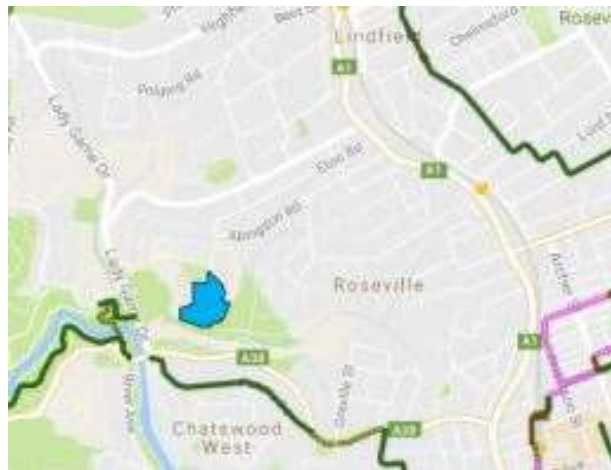
I have added a nice photo of a pedestrian walking along Abingdon road with a bus heading towards the school (of which there will be many) please note the lack of room for any other cars, bikes or students and at this point the verge on the side of the road is at around 25° so there is no other option but to walk on the road.
